Re: Minor PRD – Pre-Application - PreA23-048
8512 E. Sunnyside School Road – APN(s) 00590700017600

RE: Minor PRD, File# PREA23-048
26 Lot Subdivision
8512 E Sunnyside Blvd & Parcel # 00590700017600

SUBJECT: PREA 23-048 – Minor PRD

To: Ryan Larsen, Land Pro Group Inc.
From: Don McGhee, Assistant Fire Marshal
Date: November 20, 2023
Subject: PreA23-048 8512 E Sunnyside School Rd Minor PRD

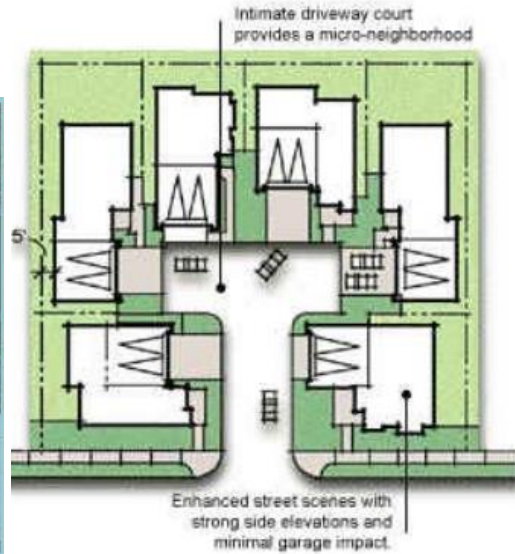
19. The autocourts proposed for lots 21-24, 1-5, and lot 12 (maybe this is supposed to be a panhandle lot?), do not meet the definition or intent and design standards of an autocourt and will not be permitted. An autocourt provides ingress and egress to clusters of dwellings; ends in a 'court' or courtyard area used for garage access and other activities; and is walled by

buildings on three sides. Autocourts shall not exceed 150 feet unless an acceptable emergency vehicle turnaround is provided. See examples of what meets the standards below.
